## === General Comments

The paper showcases the application of an ANN (likely, a multi-layer perceptron) to hindcast maximum flood depth in a HUC6 watershed in in Northeastern US based on a broad collection of (geographic, hydrologic, meteorologic, topographic, etc.) features, which were determined via a feature selection process. The model was trained on one major flood event and its "transferability" to other major flood events was evaluated yielding, in general, positive results. The paper claims, in essence, the following main contributions: (i) predicting maximum flood depth instead of presence/absence of inundation that has been examined in the literature so far, (ii) appraising the usefulness of a data-driven model on major flood events not used in training/calibration ("transferability").

Figure 7. Aggregated Shapely additive explanations (SHAP) feature importance radar plot of the maximum water depth model.

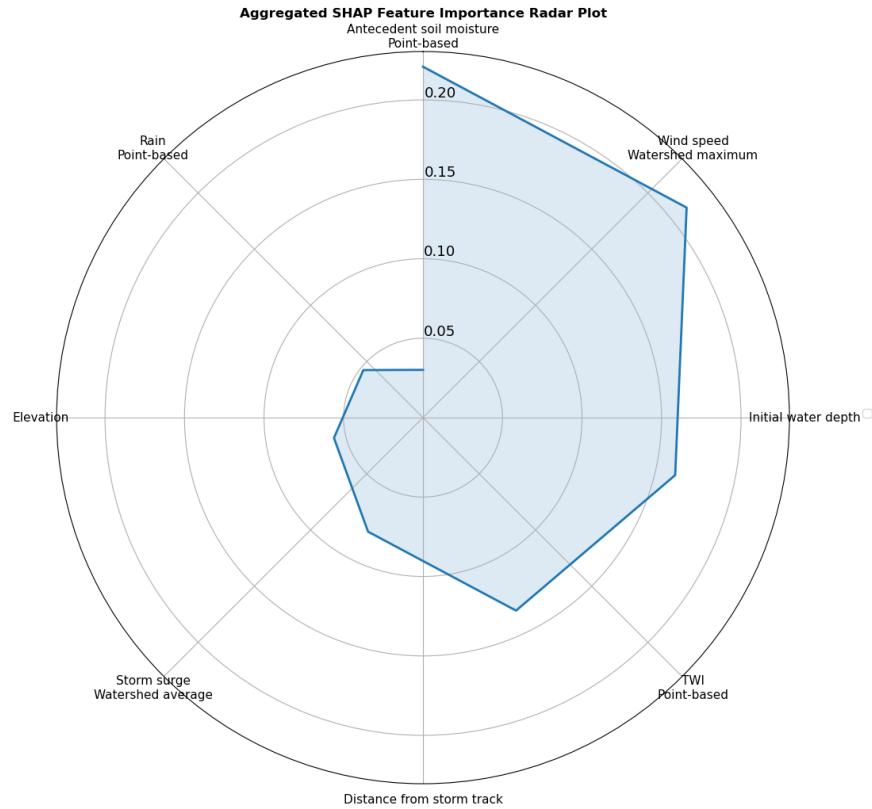
20) Figure 5: Some legends feature an underscore, which should be removed.

**Response:** All underscores in the Figure 7 (formerly Figure 5 in the original manuscript) have been removed following your comment (Line 604). The revised figure is provided here for your convenience:

Figure 7. Aggregated Shapely additive explanations (SHAP) feature importance radar plot of the ML model for hindcasting maximum water depths.

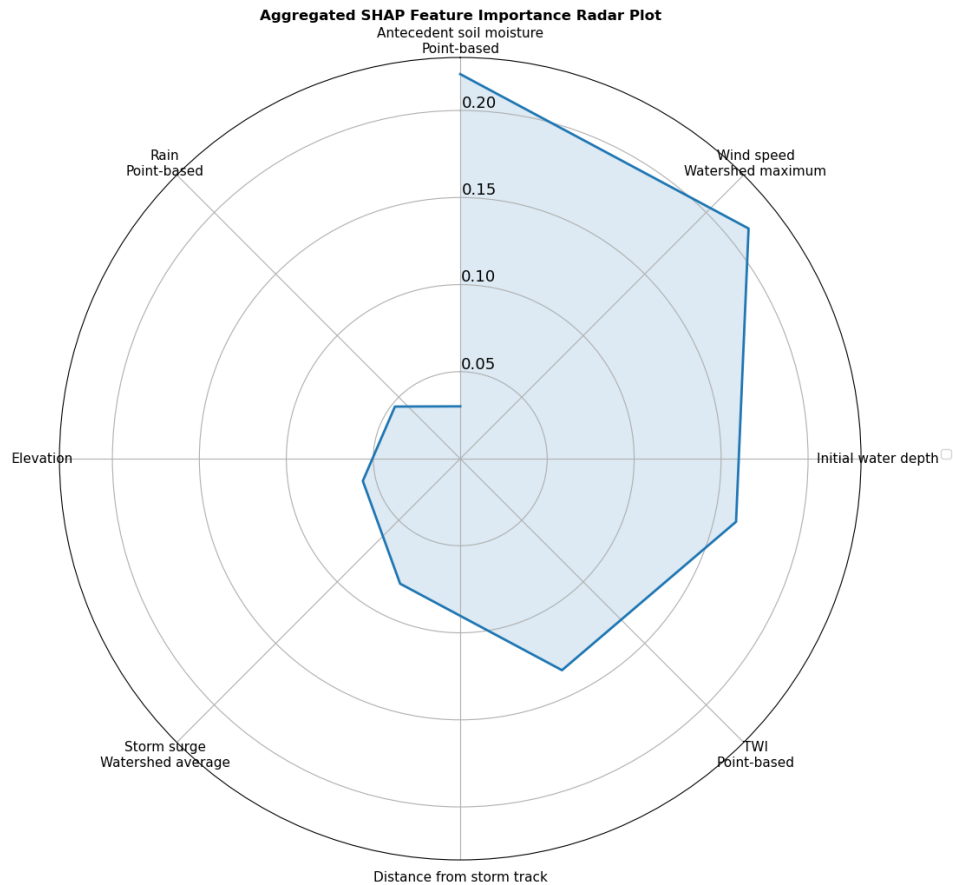
21) Line 581: "The most influential features in estimating flood depths are antecedent water level..."

From where is this concluded? I do not see "antecedent water level" as a label in Figure 5.

**Response:** We have ensured that the terminology used in Figure 7 (formerly Figure 5 in the original manuscript) matches the text description by replacing 'Mean\_GaugeHeight' with 'Initial water depth' for clarity and consistency (Line 736). The revised figure is provided here for your convenience:
